## **SHERMAN OAKS ON THE HILL SUBDIVISION**

Engineering Comments: FINAL PLAT COMMENTS (should be addressed prior to submitting the FINAL PLAT for review and/or signature by the City Engineer):

APPLICATION NUMBER 3 DATE August 15, 2019

## DETAIL SITE PLAN

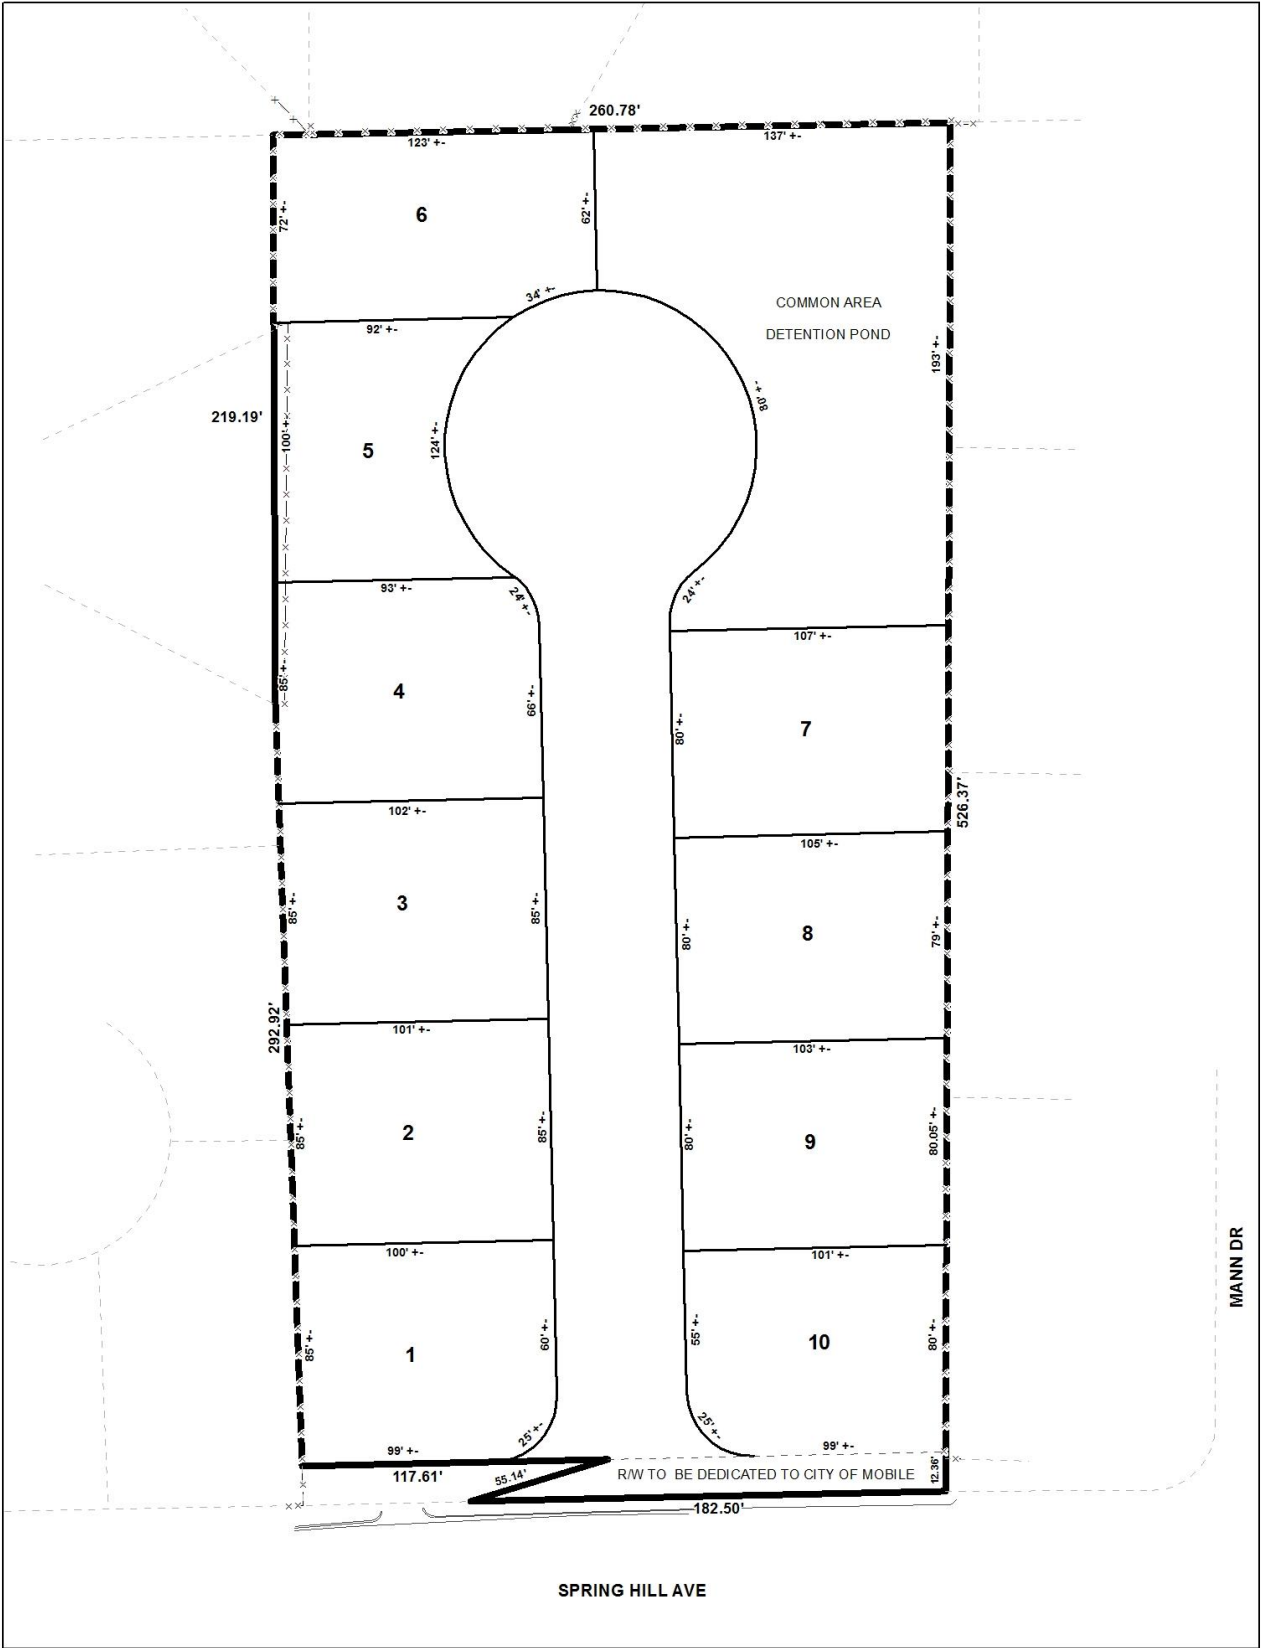
- A. Provide all of the required information on the SUBDIVISION PLAT (i.e. signature blocks, signatures, certification statements, written legal description, required notes, legend, scale, bearings and distances) that is required by the current Alabama State Board of Licensure for Professional Engineers and Land Surveyors.

- B. Provide and label the monument set or found at each subdivision corner, including the new lots.
- C. Add Mann Drive to the vicinity map.
- D. Provide the geometric data for the proposed cul-de-sac.

- E. Show and label the POC.
- F. Provide a bearing and distance for the northern leg of the proposed area to be dedicated to public ROW.
- G. Provide the acreage of the proposed ROW dedication.

- H. Add a signature block for the Owner, Notary Public, Planning Commission, Traffic Engineer, and City Engineer.
- I. Provide the Surveyor's Certificate.

- J. Provide the Surveyor's, Owner's (notarized), Planning Commission, and Traffic Engineering signatures.
- K. Provide adequate drainage easements, if needed, for the outfall from the proposed detention pond.

- L. Add a note to the SUBDIVISION PLAT stating that a Land Disturbance permit will be required for any land disturbing activity in accordance with Mobile City Code, Chapter 17, Storm Water Management and Flood Control; the City of Mobile, Alabama Flood Plain Management Plan (1984); and, the Rules For Erosion and Sedimentation Control and Storm Water Runoff Control.

- M. Add a note to the Plat stating that the approval of all applicable federal, state, and local agencies (including all storm water runoff, wetland and floodplain requirements) will be required prior to the issuance of a Land Disturbance permit.

- N. Add a note that sidewalk is required to be constructed, and/or repaired, along the frontage of each lot, or parcel, at time of new development or construction, unless a sidewalk waiver is approved.

- O. Add a note to the plat stating that all proposed detention facilities, common areas, and wetlands shall be the responsibility of the Property Owner(s), and not the responsibility of the City of Mobile.

- P. Add a note to the plat stating that all easements shall remain in effect until vacated through the proper Vacation process.
- Q. Provide a copy of the FINAL SUBDIVISION PLAT to the Engineering Dept. for review. No signatures are required on this drawing.

Traffic Engineering Comments: Driveway number, size, location and design to be approved by Traffic Engineering and conform to AASHTO standards. Lots 1 & 10 are denied direct access to Spring Hill Avenue.

The site has frontage on Spring Hill Avenue, a component of the Major Street Plan, with a planned 100' right-of-way. The preliminary plat indicates a variable right-of-way width along the site frontage with 50' from centerline on the West side, then reducing to 35' from centerline from about the middle of the site to the East side. Dedication would be required to provide 50' from centerline along the entire site, and this is indicated on the preliminary plat. The plat should be revised to indicate a 25' minimum building setback line along all street frontages as measured from any required dedication along Spring Hill Avenue.

As on the preliminary plat, the lot and Common Area/Detention Pond size labels should be retained on the Final Plat, or a table should be furnished on the Final Plat providing the same information.

The subdivision would contain a Common Area/Detention Pond. Therefore, a note should be required on the Final Plat stating that the maintenance of the Common Area/Detention Pond is the responsibility of the property owners.

As per the Traffic Engineering comments, the driveway number, size, location and design are to be approved by Traffic Engineering and conform to AASHTO standards. Lots 1 & 10 are to be denied direct access to Spring Hill Avenue. A note should be required on the Final Plat stating these comments.

- 1) dedication sufficient to provide 50' from the centerline of Spring Hill Avenue along the entire frontage;
- 2) revision of the plat to illustrate a 25' minimum building setback line along all street frontages, as measured from any required dedication along Spring Hill Avenue;

- 3) retention of the lot and Common Area/Detention Pond size labels on the Final Plat, or the furnishing of a table on the Final Plat providing the same information;

- 4) placement of a note on the Final Plat stating that the maintenance of the Common Area/Detention Pond is the responsibility of the property owners;

- 6) placement of a note on the Final Plat stating the Traffic Engineering comments: *(Driveway number, size, location and design to be approved by Traffic Engineering and conform to AASHTO standards. Lots 1 & 10 are denied direct access to Spring Hill Avenue.);*
